Serial No. 10/627,806
Amdt. dated September 14, 2005
Reply to Office Action of June 14, 2005

Docket No. P-0549

Amendments to the Drawings:

FIG.1

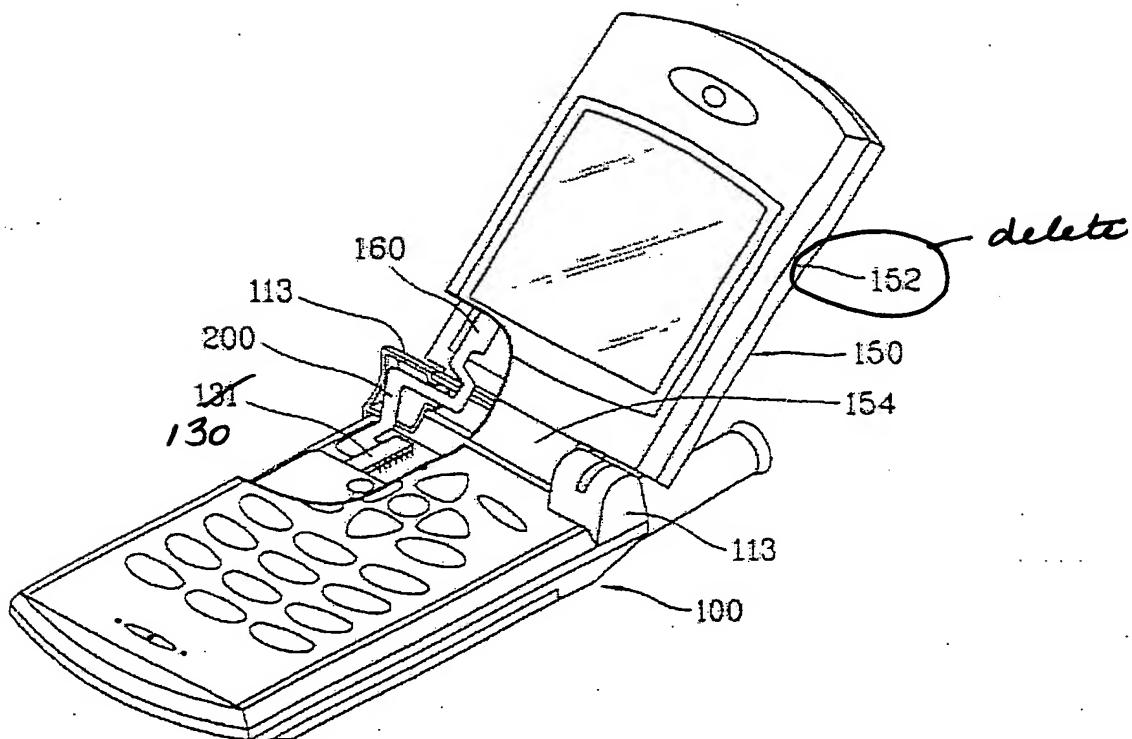
Figure 1 is amended to delete reference numeral 152, and to replace reference numeral 131 with reference numeral 130, consistent with the specification. Figure 3 is amended to reflect the proper placement of the reference line for the speaker 51. Figure 5 is amended to replace reference numerals 83 and 98 with reference numerals 68 and 93, respectively, consistent with the specification. No new matter is added.
